AGENDA
CITY OF BERLIN PLAN COMMISSION
TUESDAY JUNE 30TH, 2020 6:00 P.M.
CITY HALL COUNCIL CHAMBERS
CITY OF BERLIN, WI

May 28, 2020
Revised June 24, 2020

RE: ThedaCare Berlin Emergency Department
Building Addition Site Plan Review

C100

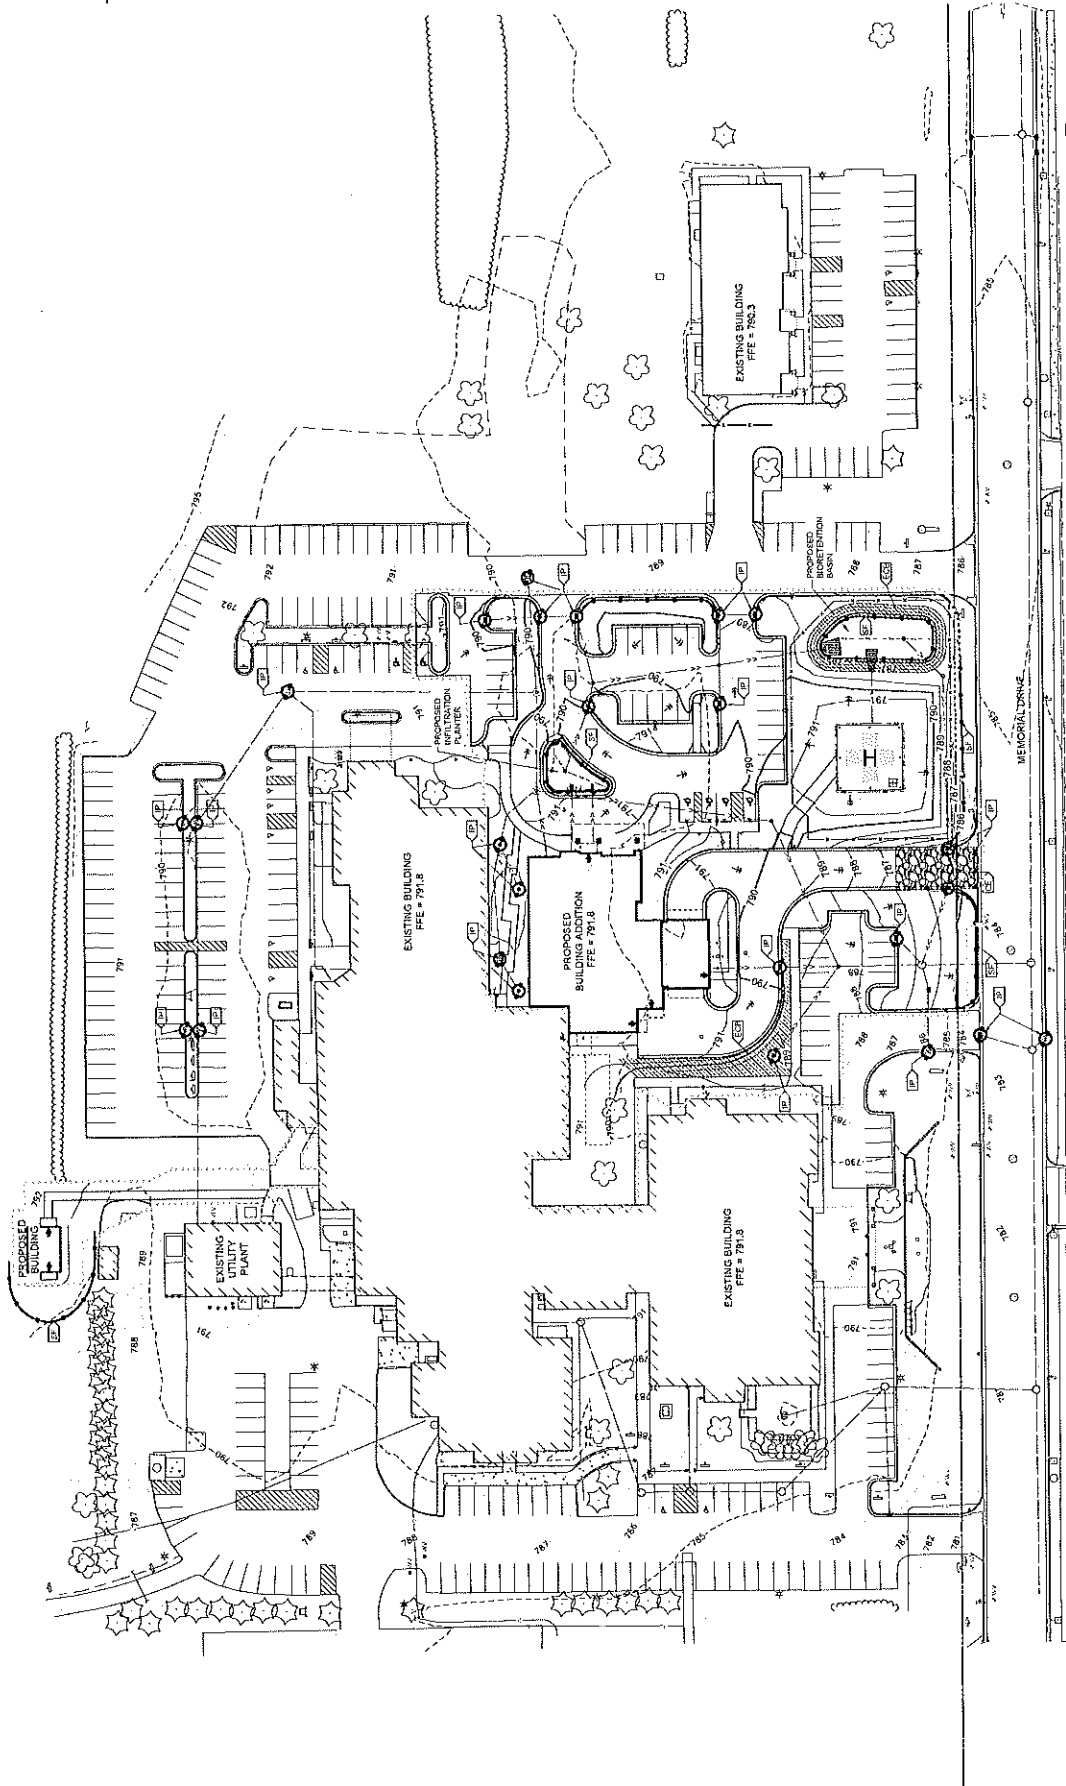
- Installation of a stone tracking pad at the new driveway from Memorial Drive which will serve as the construction entrance
- Provisions for storm inlet protection over all existing and proposed storm water inlets
- The installation of an erosion control blanket over the hillside flanking the ambulance driveway due to steep slopes
- The erecting of silt fence along the North ROW of Memorial Drive and downstream (West) of the proposed building intended to house the emergency generator

In addition to the BMPs the plans dictate requirements for undertaking sitework and grading activities ensuring that erosion control measures will be in place, inspected and a maintained throughout construction of the project. As construction of the project is being bid as "design-build," the prime construction contractor will be held responsible for submittal of the Notice of Intent(NOI) pursuant to NR 151 requirements, securing all permits and both the installation and maintenance of all erosion control devices. In addition, the storm water pollution control notes require the contractor to inspect and clean any sediment deposited on the roadway daily. Provided that all the erosion control BMPs are installed, inspected, and maintained as provided for within the plans, the provisions appear to be adequate and meet both State and City requirements.

- 2) That all Erosion Control BMP's, as reflected within the plans, be installed and maintained pursuant to the plans, specifications, and NR 151 standards. In addition, all erosion control devices are to be installed prior to the initiation of the construction project. (HGA 6/11/20 email-Boldt Contractors Inc., the building General Contractor, is the responsible party to ensure that all erosion control BMPs are erected and maintained throughout construction of the project)

LIGHTING
PHOTOMETRIC
PLAN

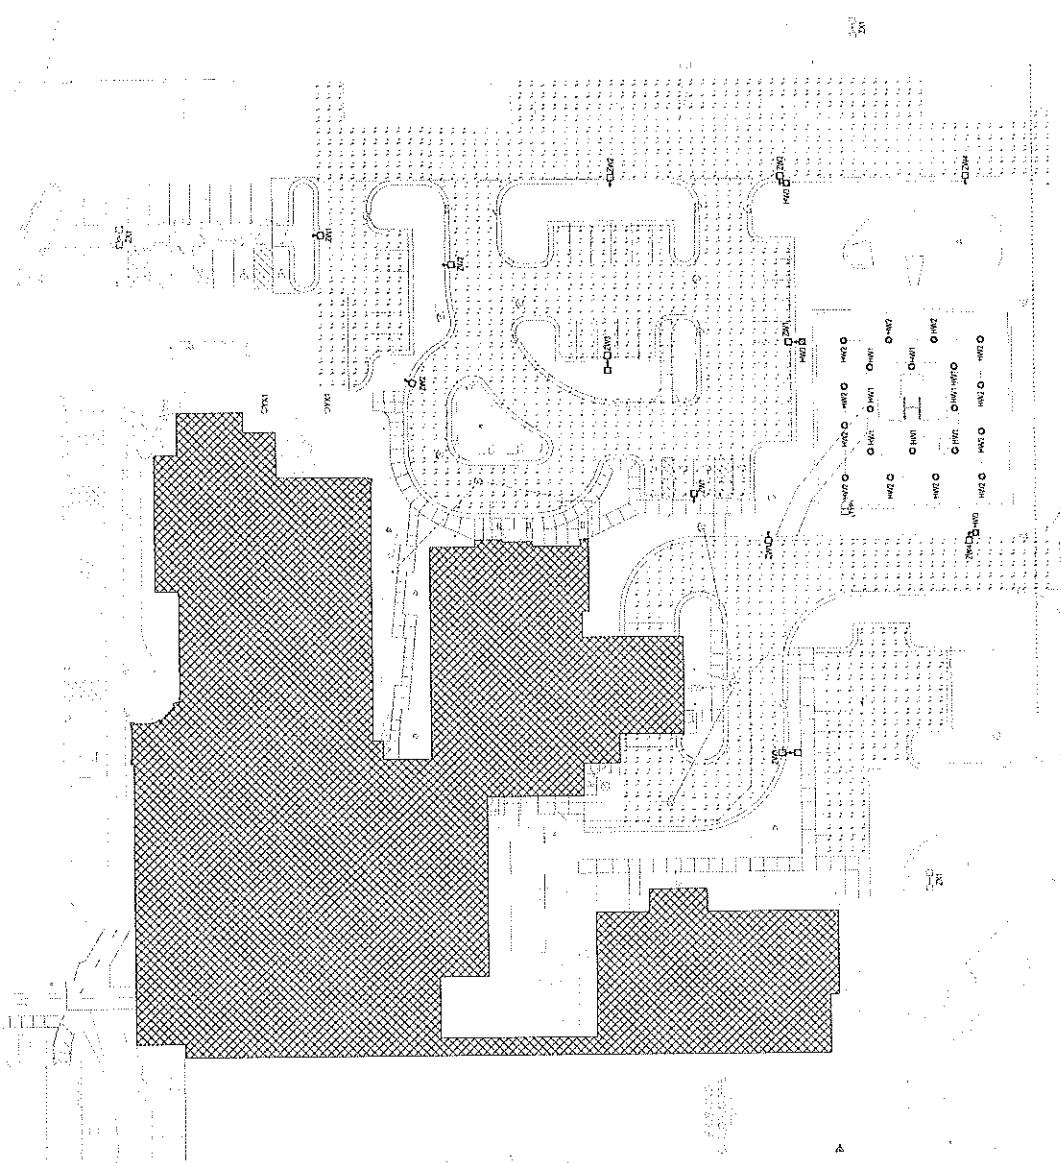
The layout of the lighting within the parking lot appears typical for similar institutional parking lot installations. The photometric plan, as submitted, reflects that the illumination emitted from the exterior lights will not exceed 0.5 foot-candles at the property line. This conforms with the general guidelines established by the City of Berlin.

! LIGHTING SITE PLAN - PHOTOMETRICS
26.5 x 14"

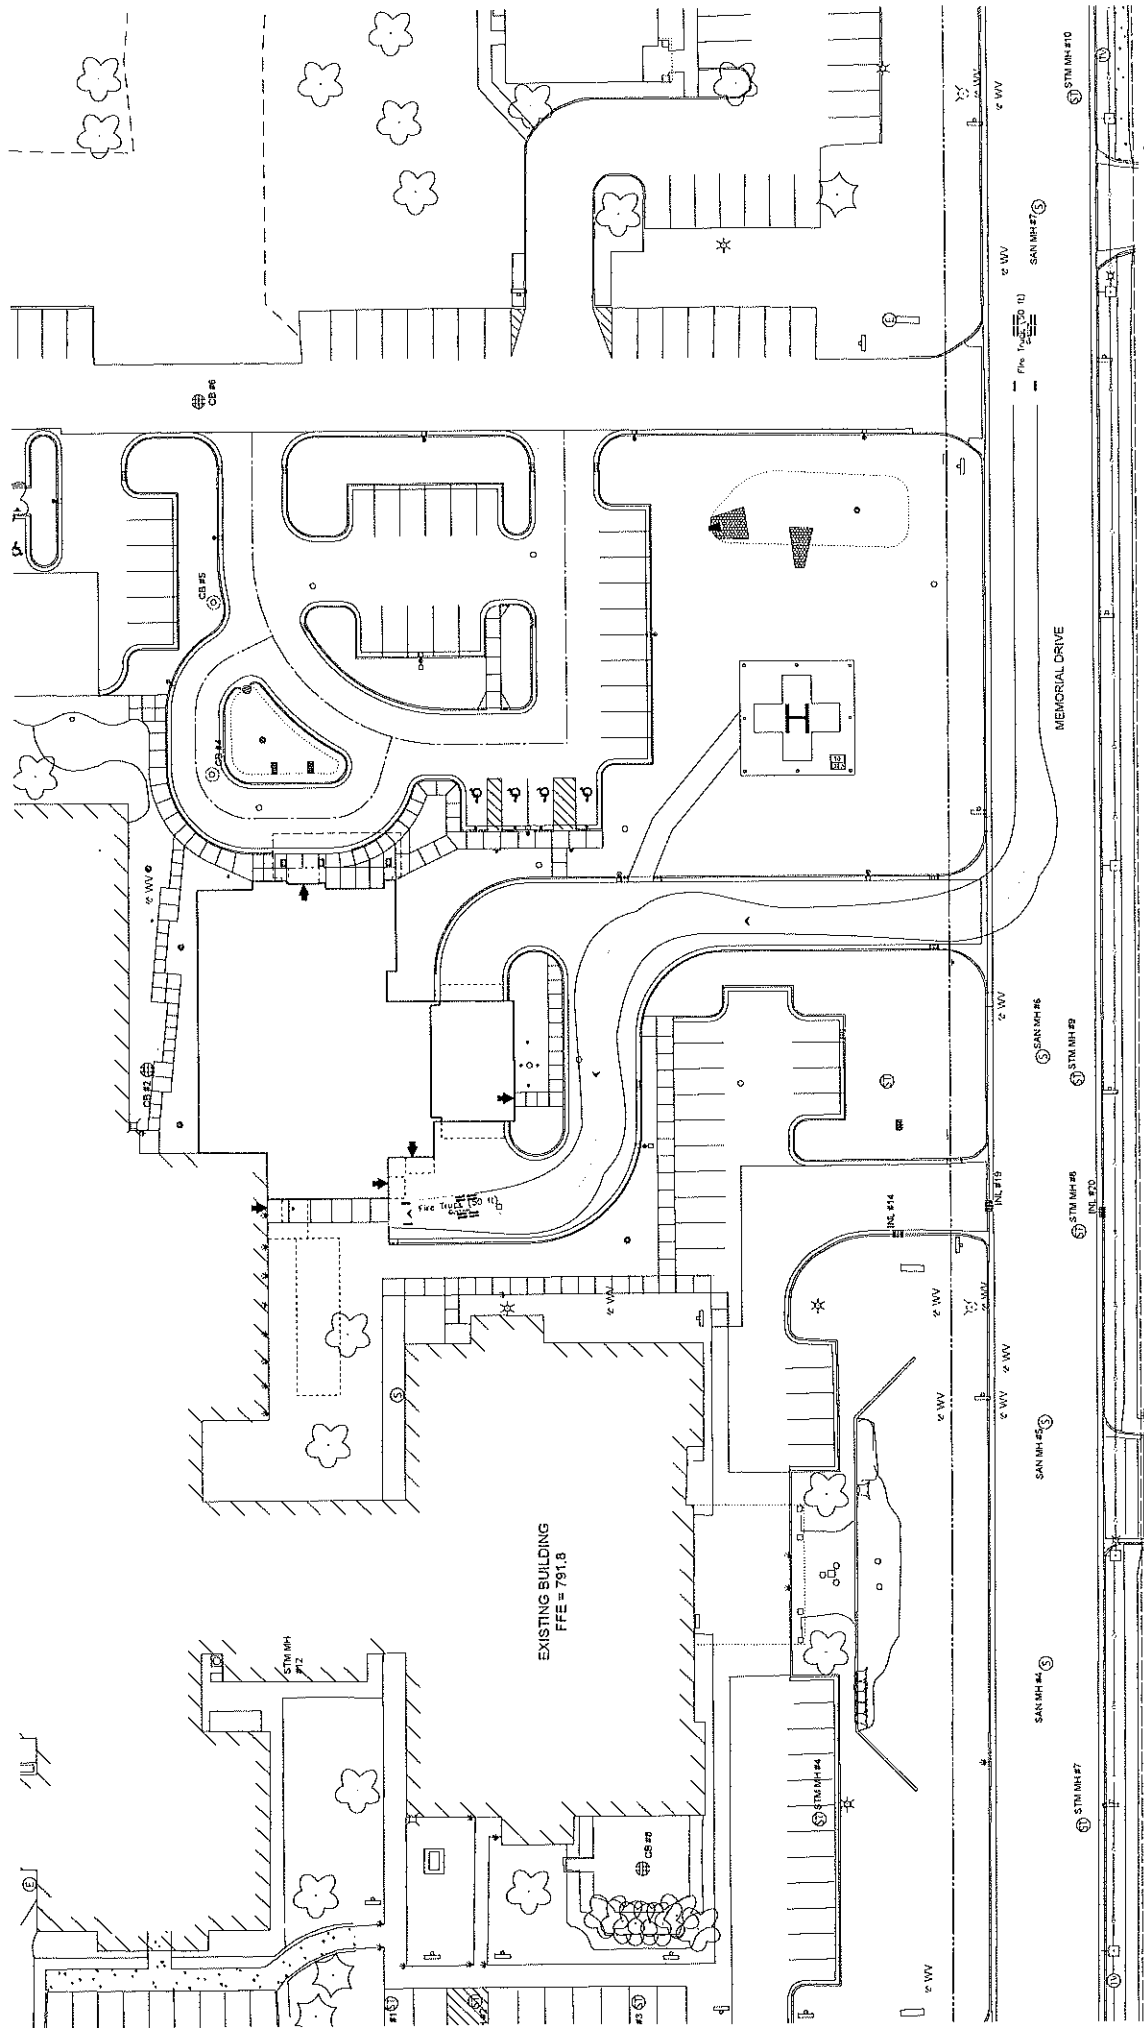
A question has been raised relative to the ability of a fire engine to adequately access the emergency room entrance driveway from Memorial Drive. The "AutoTurn" diagram, subsequently submitted under cover of the HGA email of June 11th illustrates that a 50-foot long fire truck could access the driveway to the Emergency Room.
